PROJECT NO. U-0620  
 CUMBERLAND COUNTY  
 STATION: 161+95.29 -L-

SHEET 1 OF 3

**SUBSTRUCTURE  
 END BENT 2  
 (LEFT LANE)**

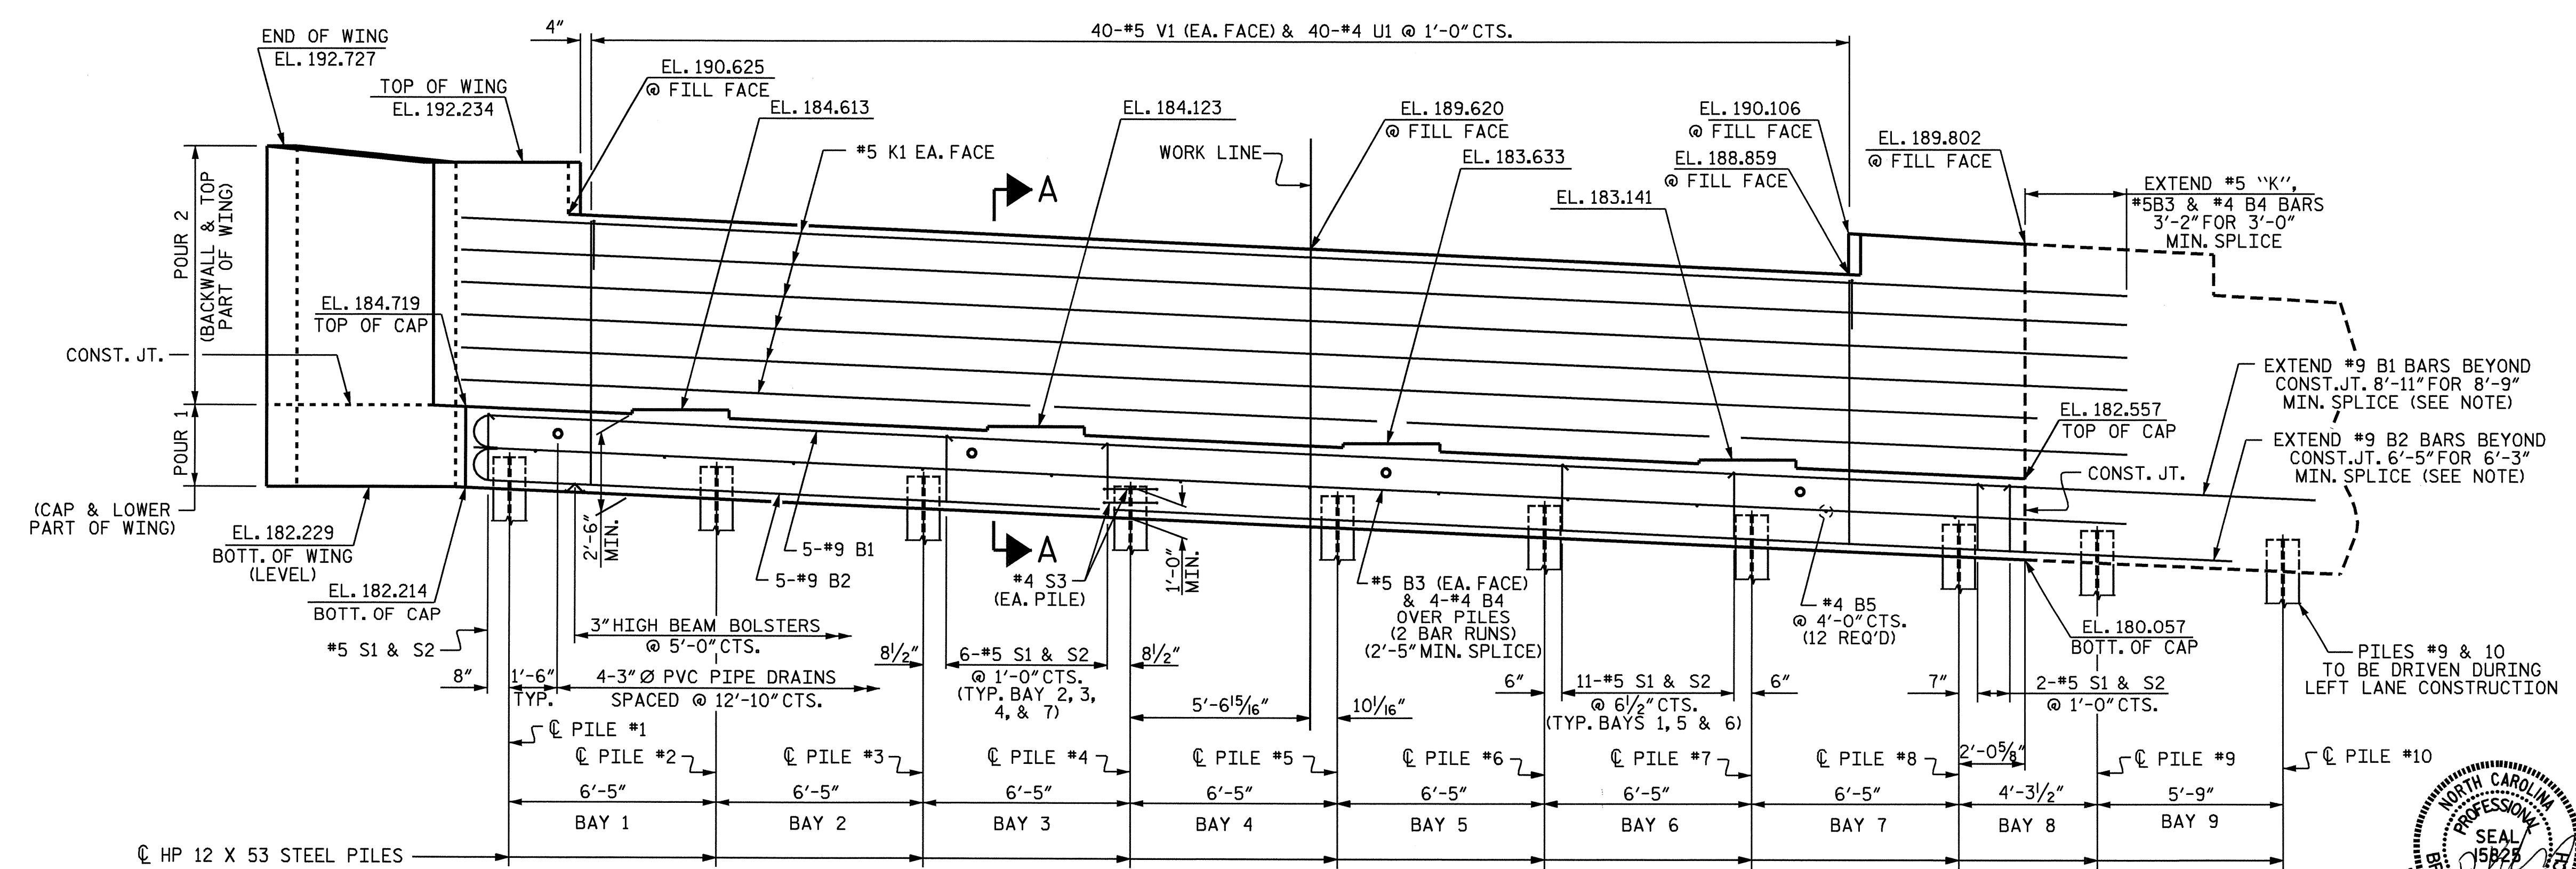
REV: CHANGE BRACE PILES TO VERTICAL PILES.  
 DRAWN BY: M.G.S.  
 CHECKED BY: B.D.K.
